Our ref: NO/2025/117140/01-L01
Your ref: 3/2025/0873
Date: 28 November 2025

**CONSTRUCTION OF 6 DETACHED DWELLINGS WITH ASSOCIATED PARKING
AND LANDSCAPING AT LAND OFF SPRINGWOOD DRIVE.**

LAND AT SPRINGWOOD DRIVE, WHALLEY, BB7 9XL

Environment Agency position

Figure 1: Whalley 2017 modelled information locations

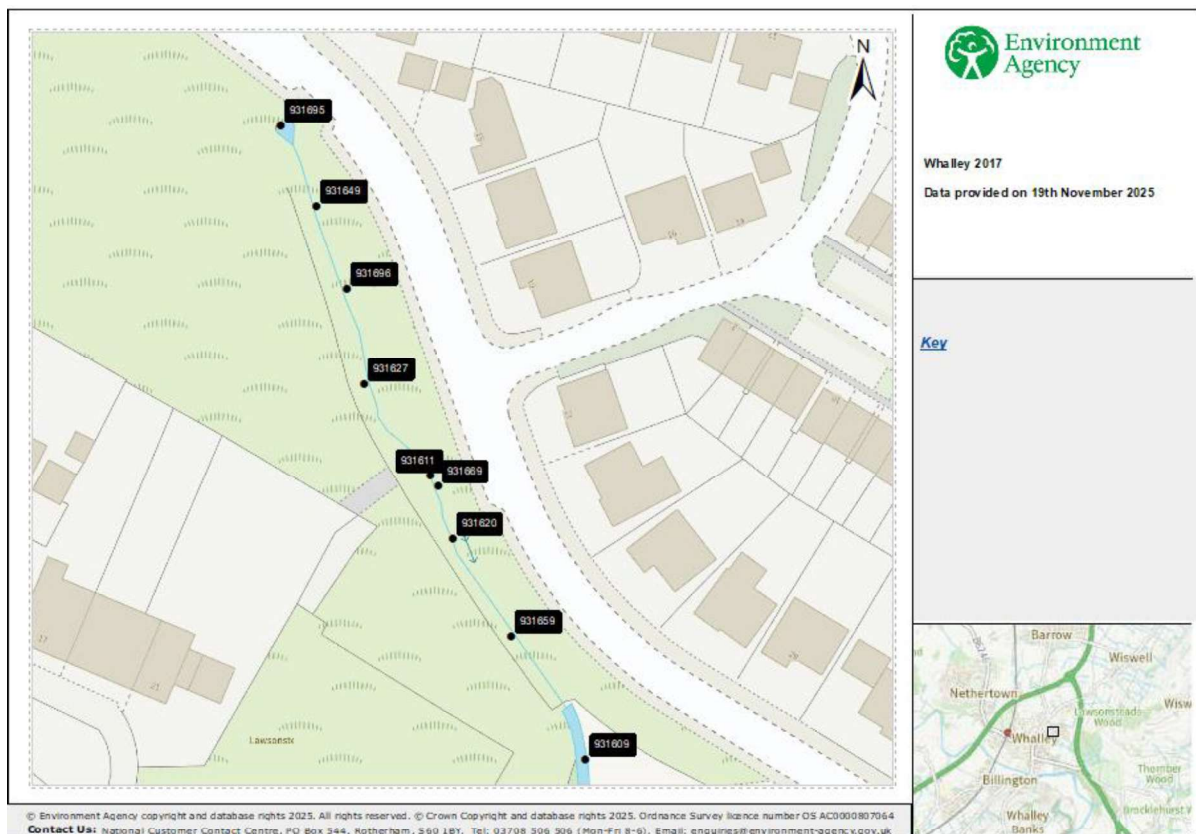
In the ‘Product 4’ dataset issued to the applicant (Appendix B in the FRA), the Environment Agency only provided 1d hydraulic modelling information for nodes 6 (931627) and 7 (931620). Information for nodes 931611 (Easting, Northing: 373618,436540) and 931669 (Easting, Northing: 373619,436538), which are located between nodes 6/7, was not provided. The data from these nodes should inform the updated FRA – see Figure 1 and Table 1 below:
